VN(4) Cab Leveling Bar Loose

Release: 1**Technician Skill Level:** A**Revision Note:** 12/2025 Initial Release**Market:** North America**Service Category:** Service Department**Applicability:** Please refer to VDA+**Section:** Function Group 818**Description:**

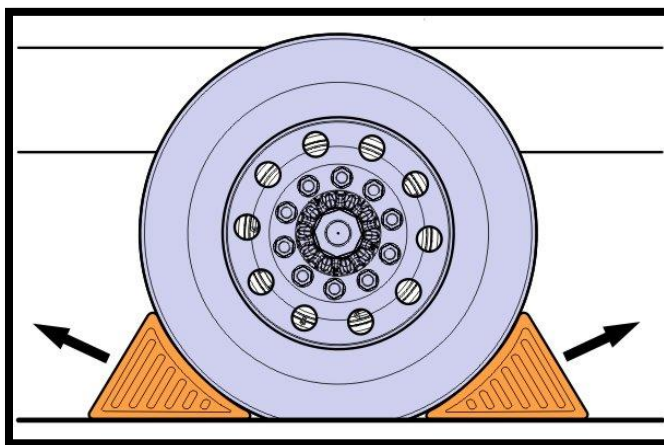
6. Follow **Impact procedure 8181-03-02-35 Panhard Rod Bracket, Replacement** to replace all suspected hardware. Brackets will be re-used. **Replace only the bracket hardware and torque to specification.**

Tightening torque	
Grade 10.9 Flange Screw (PN: 60114105)	105 ± 20 Nm (77 ± 15 lbs·ft)
